MINOR HISTORIC DESIGN REVIEW CASE NO.: HIS21-19

SUMMARY: A proposal to replace an existing non-historic window and door and add an additional window on the rear of the historic contributing French House (1925).

**HISTORIC DESIGN REVIEW CASE NO. HIS21-19
DECISION**

LOPEZ WINDOW REPLACEMENT
446 OAK ST
SALEM, OR

Line #1	Mark Unit:	Net Price:		1,570.83
Qty: 1		Ext. Net Price:	USD	1,570.83

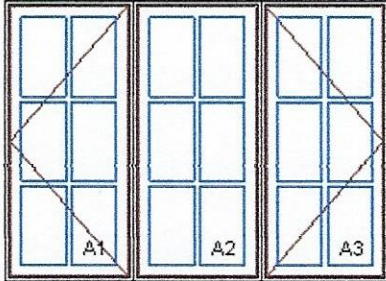
Building and Safety reviewed the proposal and had the following comment: "The proposed new add-in window will need to be assessed for the vertical and lateral design of the structure. The placement of an opening in that wall with minimal structural panels on either side can weaken the structure. If the other window and the French doors do not widen the current openings the Building Department has no issues with them."

Finding: No photo or other evidence has yet been discovered detailing what the windows at the rear of the structure looked like before the remodel in the 1970s or 80s. The rest of the home has double-hung wooden windows with a plain trim. The existing kitchen window is currently a two-panel slider and the size and shape of the opening would not translate well to a double-hung window style. The applicant has suggested another window type, a casement style window which emulates the style of a paned window, also found on historic windows around the house.

This standard is met.

Line #2	Mark Unit:	Net Price:		781.12
Qty: 1		Ext. Net Price:	USD	781.12

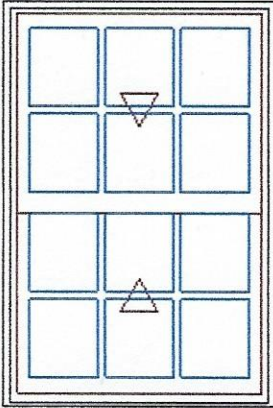
The window proposed for installation in a new opening is a double-hung window, emulating the style of the other windows on the house.
